Access audit

Marlbury Civic Library, Market Walk

Client	Marlbury Borough Council
Building	Marlbury Civic Library, 3 Market Walk, Marlbury
Reference	RK-2026-0509
Audit date	06 May 2026
Auditor	Hannah Petrakis

Photograph 2 — External steps and ramp (approach)

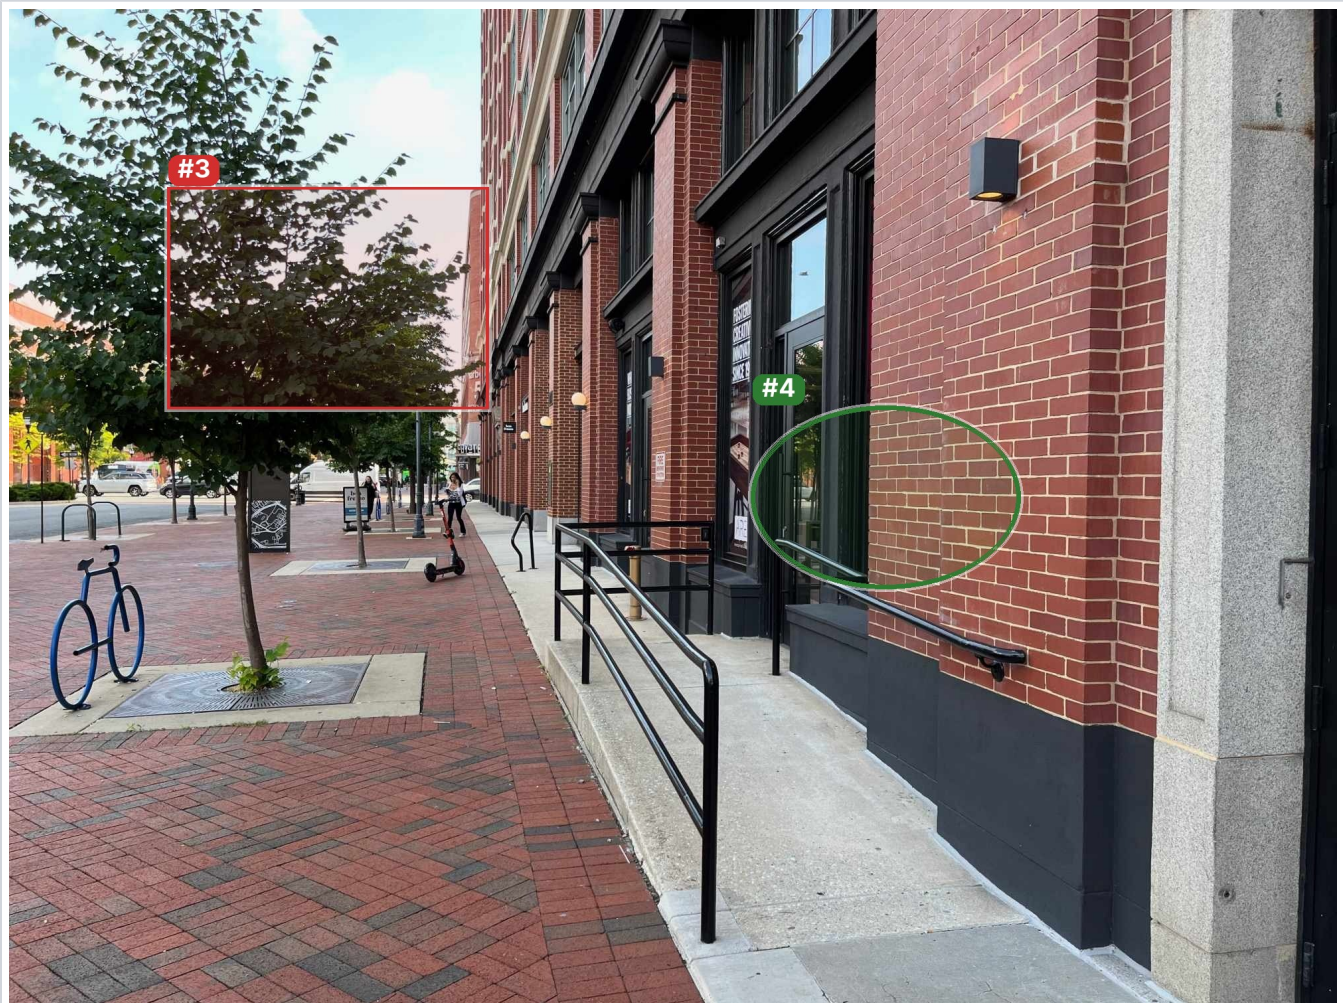
#	Rating	Fault type
#3	A	Step nosings
Barrier: nosings not visually contrasted and a handrail on one side only. Recommendation: fit 55 mm contrasting nosings and a second handrail.		
#4	C	Obstruction
Relocate the cycle stands clear of the path.

Photograph 4 — Accessible route (horizontal)

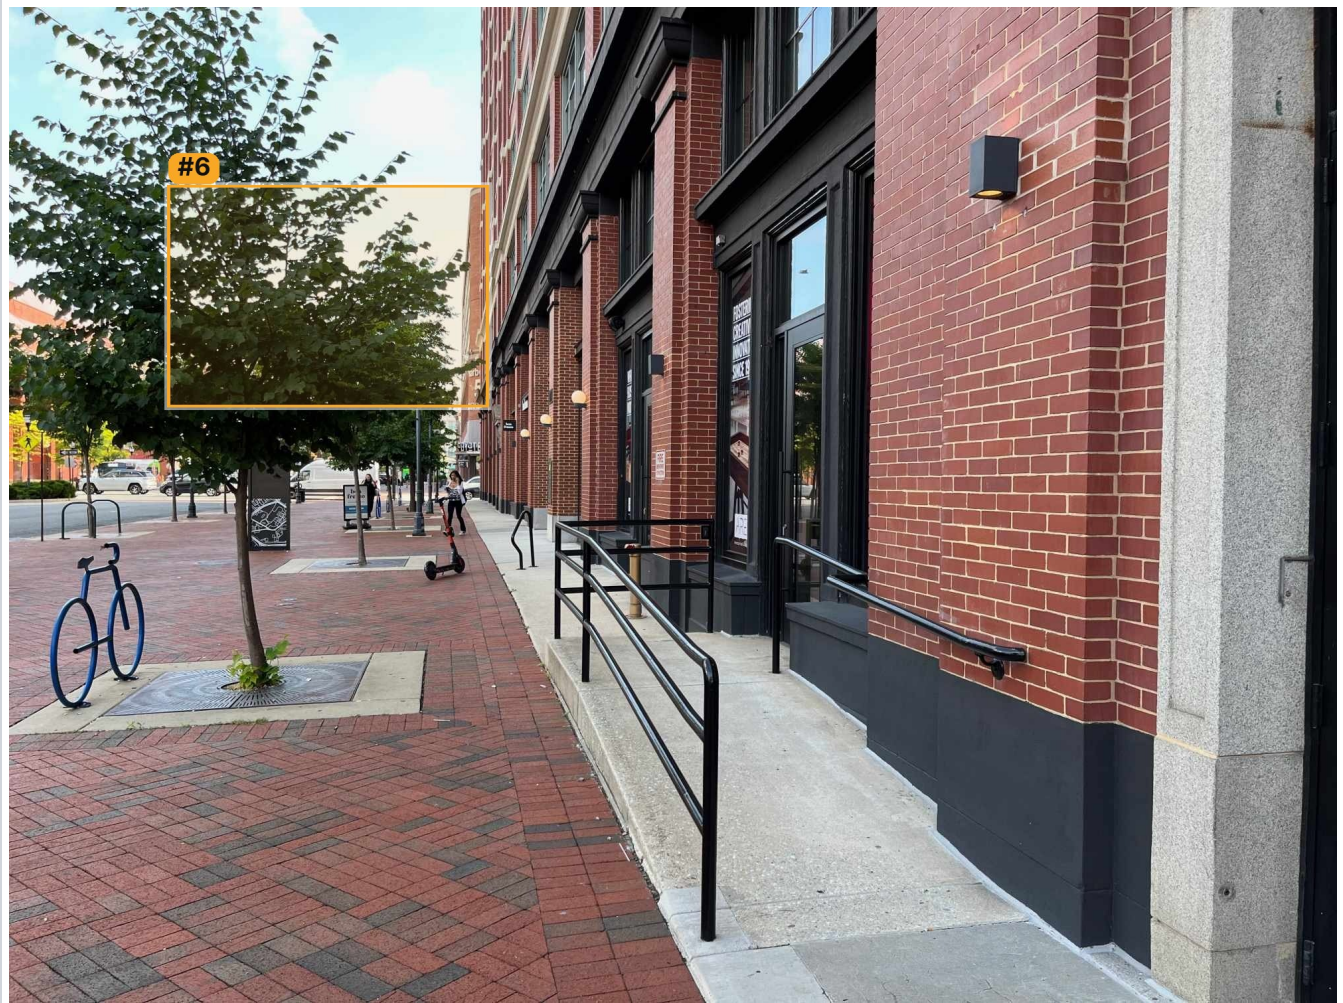
#	Rating	Fault type
#6	B	Level change
Unmarked 20 mm step at the stock room; form a short ramp and mark the edge.
